Agenda Item # 11

SUB-002996-2024 & SUB-SW-002972-2024

Anglebrook Subdivision

- Subdivision approval to create 108 legal lots of record.
- Waive construction of a sidewalk along McFarland Road.

SITE PLAN

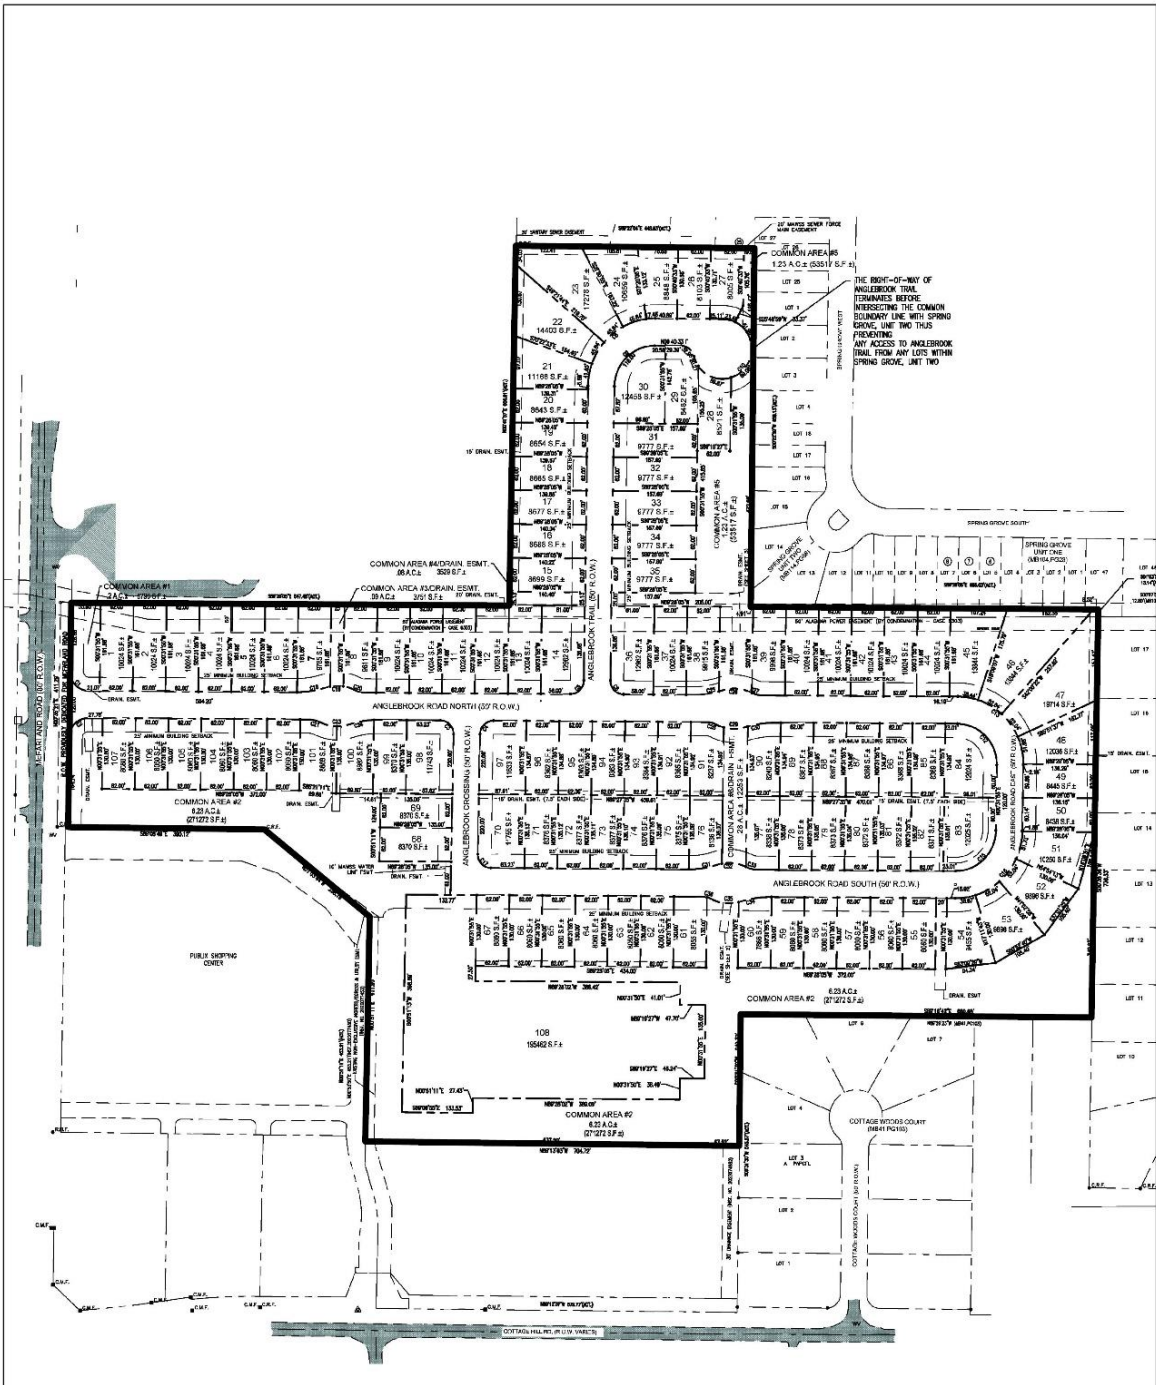
- A. Provide all of the required information on the SUBDIVISION PLAT (i.e. signature blocks, signatures, certification statements, written legal description, required notes, legend, scale, bearings and distances) that is required by the current Alabama State Board of Licensure for Professional Engineers and Land Surveyors.

- B. Provide and label the monument set or found at each subdivision corner.
- C. Provide the recording data for the previously dedicated ROW on McFarland Rd.

- D. Label every proposed drainage easement as "PRIVATE"; except that the drainage easement between LOT 76, 77, 90, and 91 shall be labeled as "PUBLIC".

- E. Provide a table of "PROPOSED WEIGHTED RUNOFF COEFFICIENT (Cw)" for each LOT.
- F. Add a signature block for the Owner, Notary Public, Planning Commission, Traffic Engineer, and City Engineer.

- G. Add a note that the proposed roadway and stormwater improvements shall be complete and approved prior to issuing any residential construction permits.

The preliminary plat indicates a Common Area on the North and South sides of the entrance street (Anglebrook Road North) off McFarland Road with a 25-foot minimum building setback line off both streets, and this should be retained on the Final Plat, if approved. Throughout the rest of the subdivision, a 25-foot minimum building setback line is illustrated along all lot frontages and Common Area frontages. This should be retained on the Final Plat, if approved.

All lots and Common Areas are dimensioned on the preliminary plat and labeled with their areas in both square feet and acres. All proposed lots meet the minimum size requirements of Section 6.C.2(b)(2) of the Subdivision Regulations for residential lots located within an area designated as Suburban in the Unified Development Code. The lot dimensions should be retained on the Final Plat, if approved, as well as the lot size labels, or a table should be furnished on the Final Plat providing the lot sizes in both square feet and acres. Proposed Lots 22, 23, 24, 46

and 47 would exceed the depth-to width ratio of Section 6.C.3. of the Subdivision Regulations and would require a waiver of that section, if approved. No lot number label was provided on Lot 77; therefore, the plat should be revised to label Lot 77.

It should be noted that proposed Lot 108 is intended to be a multi-family development within the proposed single-family subdivision. This concept was approved when the subdivision was originally reviewed and approved by the County Commission prior to annexation. As there is no zoning within the unincorporated areas of the County, this concept was allowable. However, now that the site is within the City of Mobile, Lot 108 cannot be developed for multi-family residential use until its area is rezoned to at least an R-3, Multi-Family Residential Suburban classification. The ZONING table on the preliminary plat should be revised to R-1, Single-Family Residential Suburban on the Final Plat, if approved.

One (1) of the proposed streets into the subdivision is indicated to be over 600 feet in length terminating in a cul-de-sac. Section 6.B.3. of the Subdivision Regulations states that closed-end streets shall not, ordinarily, be over 600 feet in length. Therefore, if approved, a waiver of Section 6.B.3. would be required. All proposed streets are indicated to have a compliant 50-foot right-of-way, and the right-of-way width of all streets should be retained on the Final Plat, if approved.

There are numerous Common Areas proposed within the subdivision. Therefore, a note should be required on the Final Plat, if approved, stating that the maintenance of all Common Areas is the responsibility of the property owners and not the City of Mobile. The preliminary plat also indicates numerous drainage and utility easements throughout the site. Therefore, if approved, a note should be placed on the Final Plat stating that no structure shall be constructed or placed in any easement without permission of the easement holder.

There are multiple corner lots, each requiring a 25-foot corner radius where the proposed streets will intersect, per Section 6.C.6. A table on the plat indicates the site will comply with this requirement and should be retained on the Final Plat, if approved.
